WBS 3.0, C-0 Outfitting **Portion of the** **BTeV Project**

C-0 Outfitting
WBS 3.0
BTeV Project
Advanced Conceptual Design Report
April 2004

FESS/Engineering Project No. 6-8-3
Rev. 0

Stakeholder Input from Comment and Compliance Review

ELECTRICAL - PLAN AT EL. 715'-0"

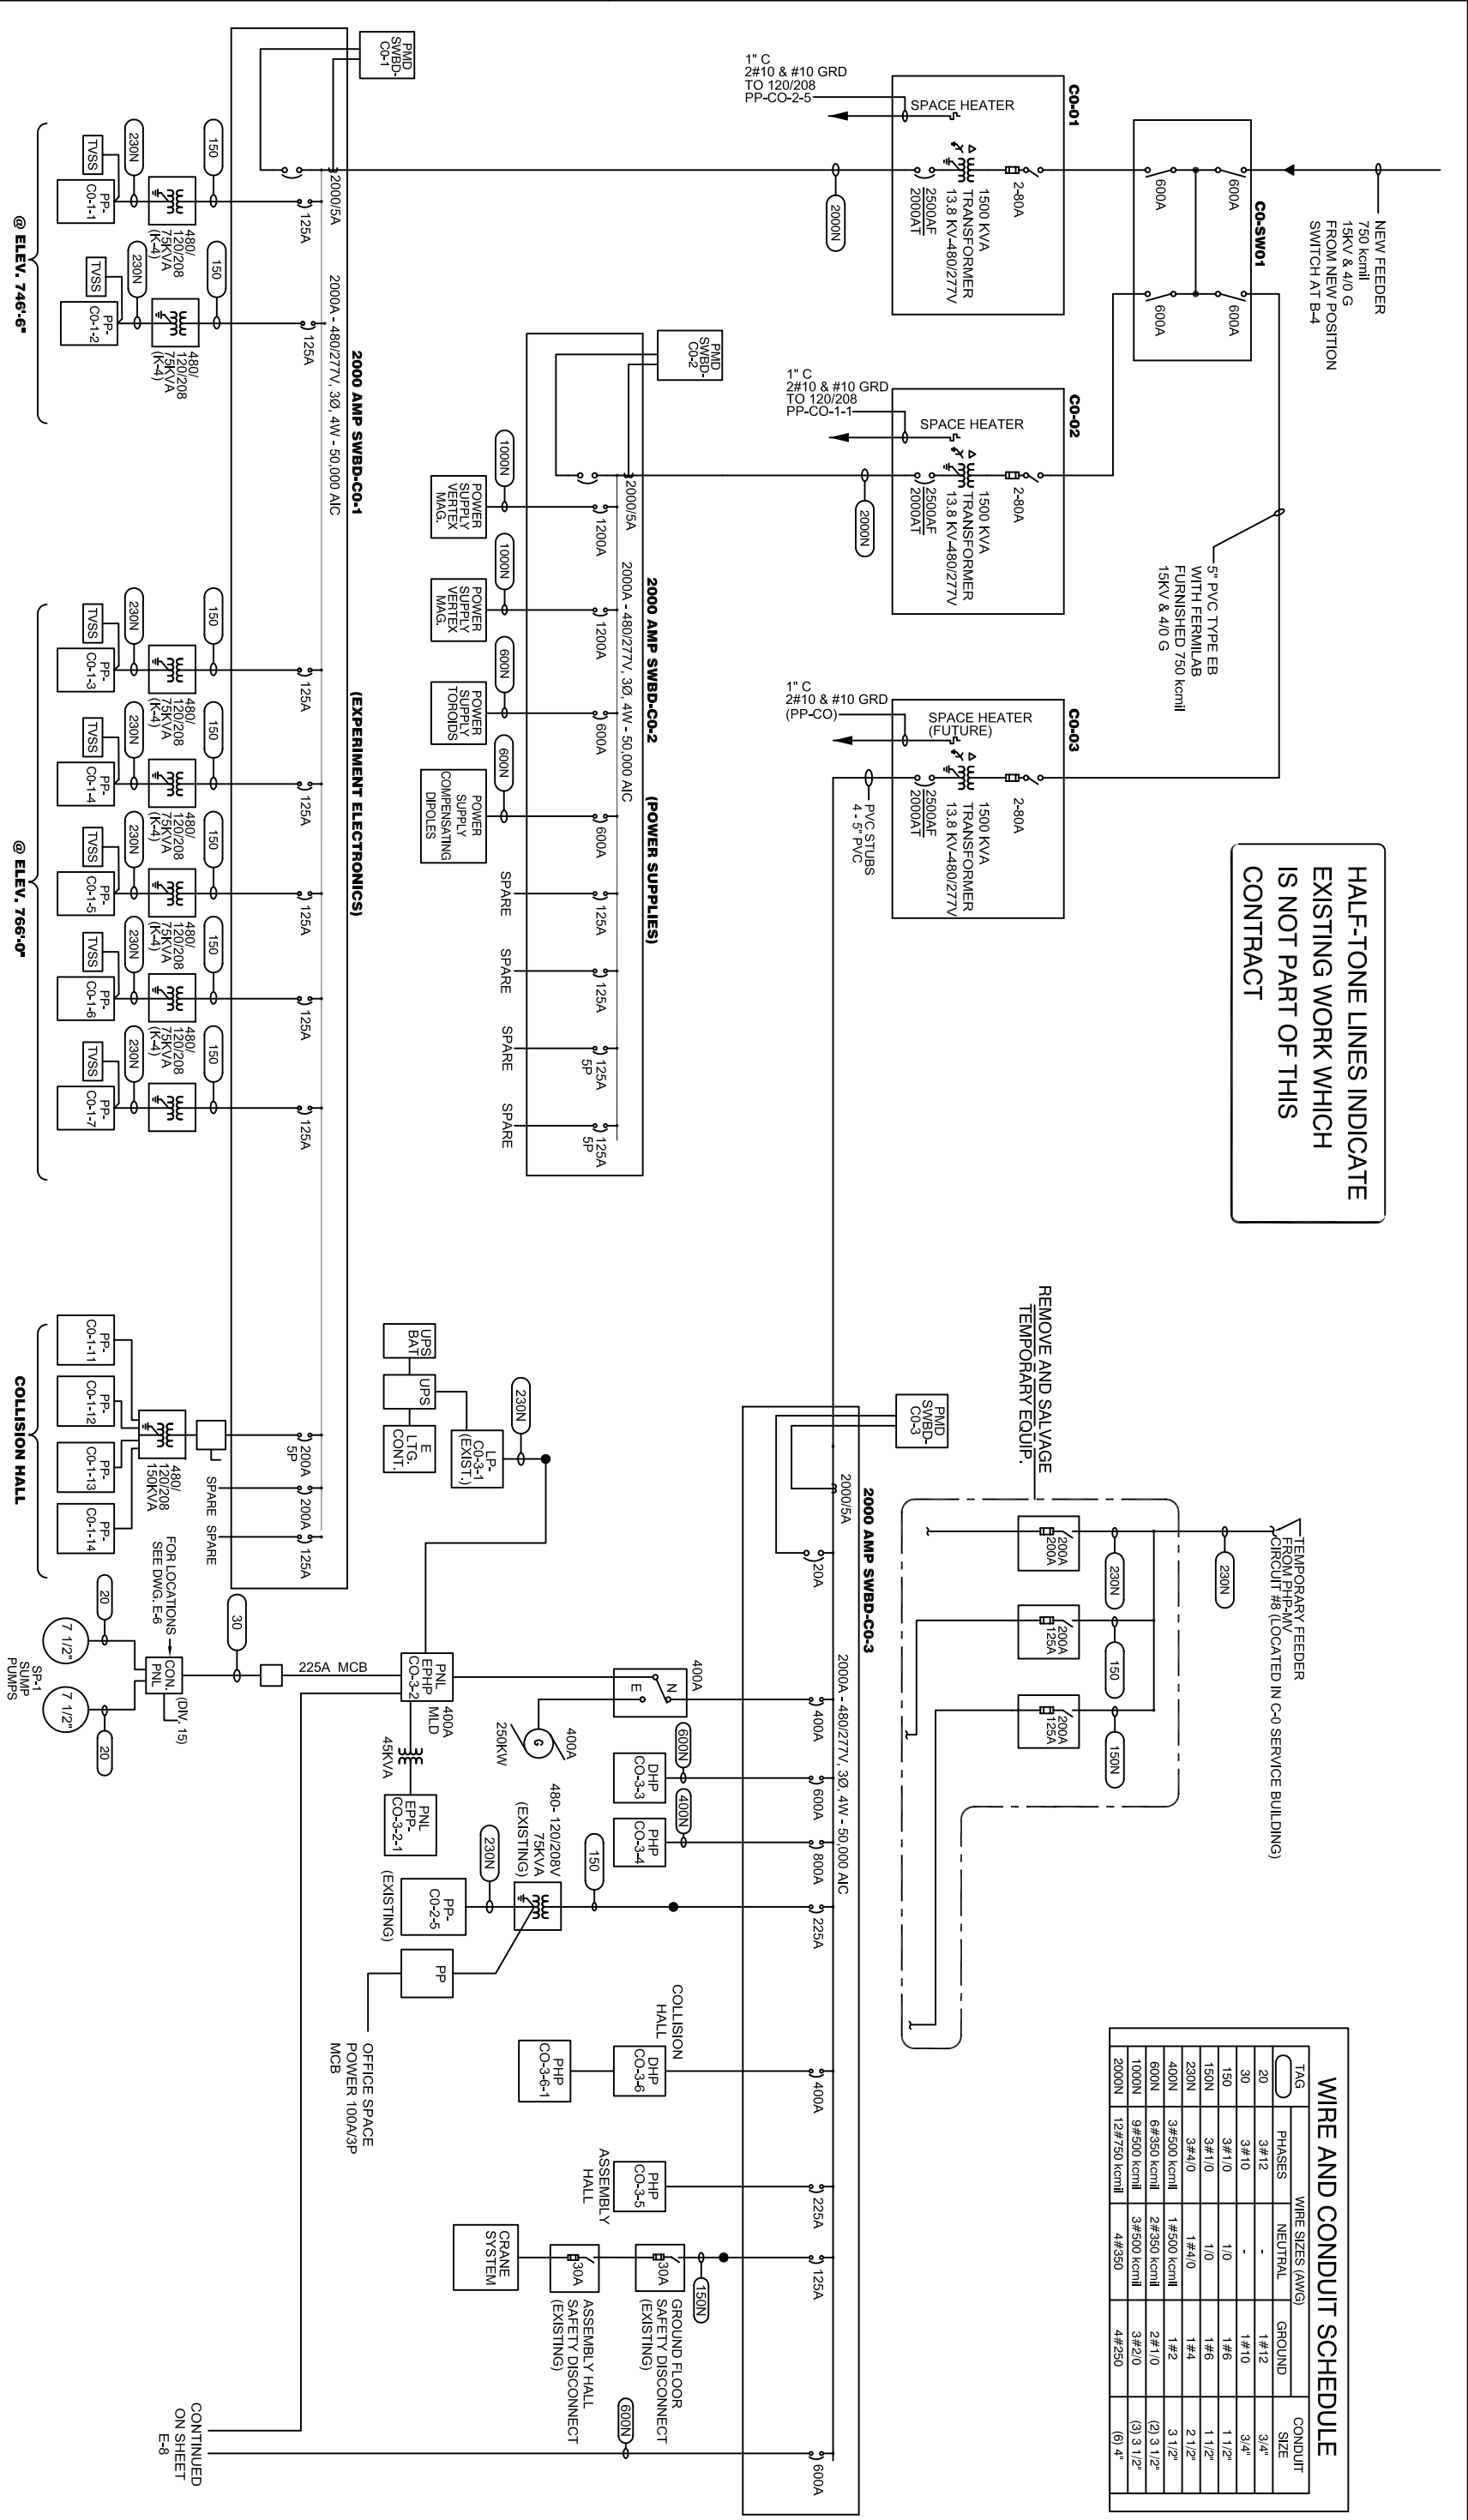
Also John Riordan has to understand how to install, maintain, service, remove above ground water cooled bus in the 3'x3' duct. There should be discussion on ODH and Radiation safety for contractors, specifically when entering C0 Experimental Hall without isolation from Tevatron tunnel, for work shown on drawings M-6 and E-6.

C-0 BUILDING SINGLE LINE

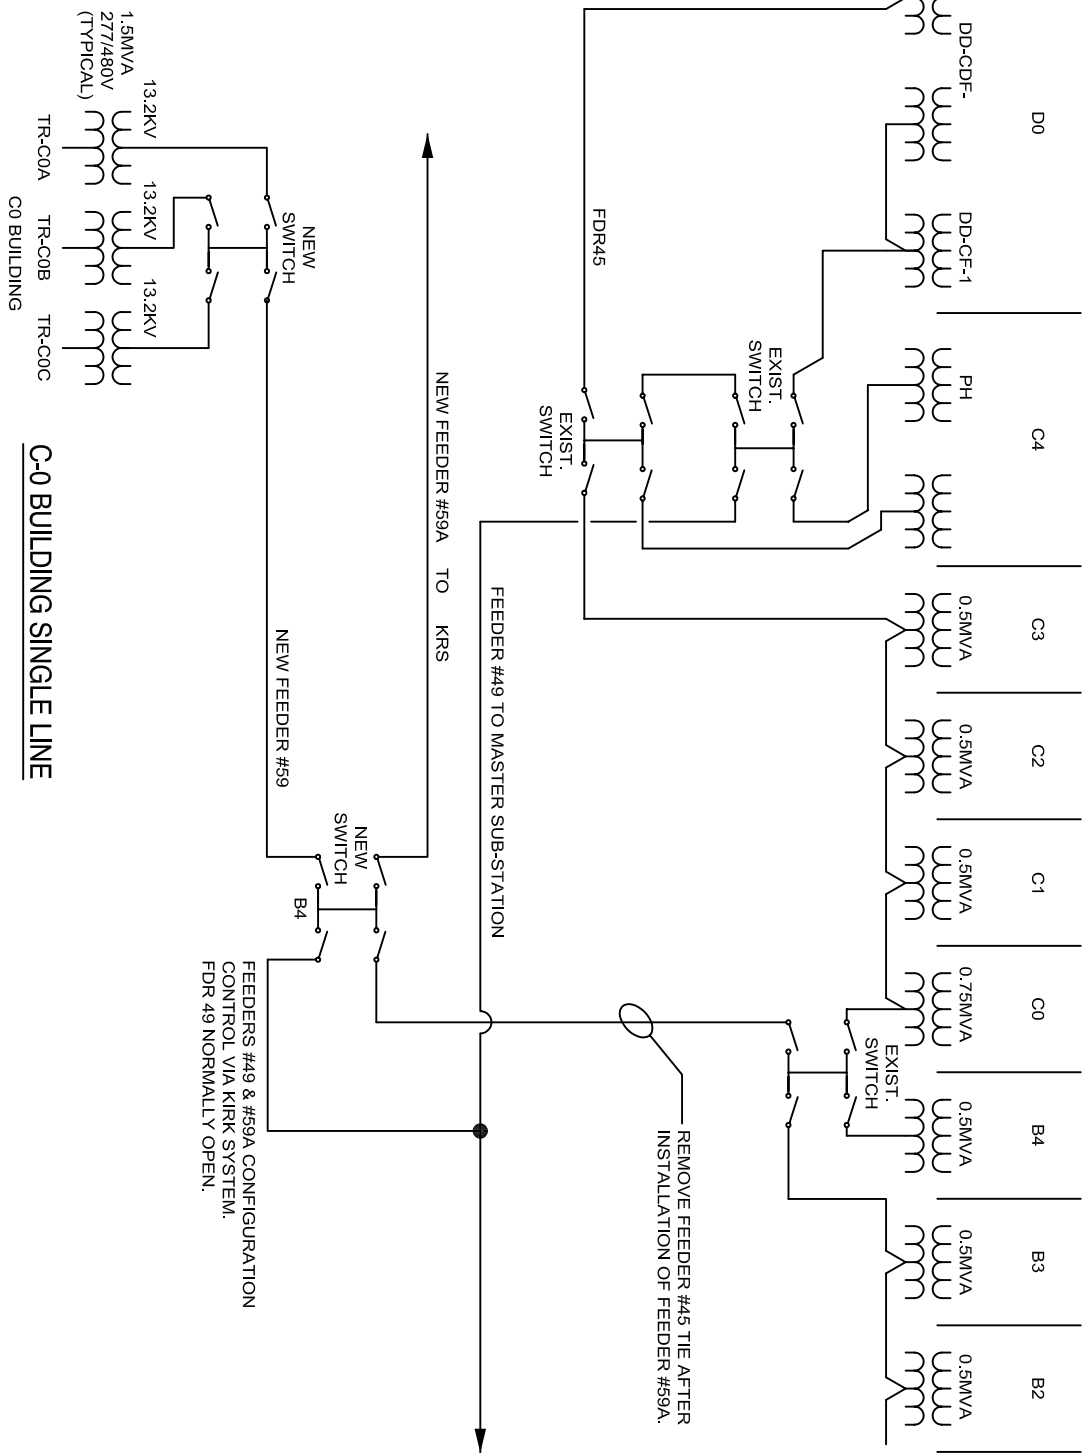
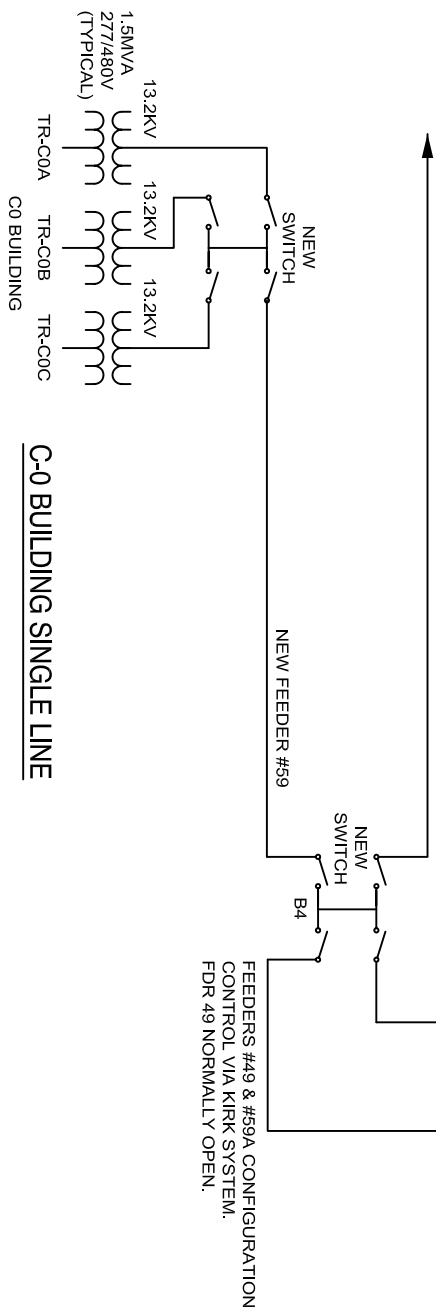
The one-line drawing shows two 75 KVA transformers that service the 1st floor counting room. If we look at page M-2 of drawing 6-8-3, we find 58 relay rack positions and a total power draw estimate of 132 kW. Division gives about 2kW per rack position; many relay racks already determined in the experiment have power draws in excess of this number. Further, the 132kW expected load is dangerously close to the 150kW of total AC available from the two transformers. We should probably allow for larger transformers - or a third 75KVA unit.

The space available as the drawing shows only allow for roughly 45 racks. We will verify that the supplied power is adequate for the rack electrical loads.
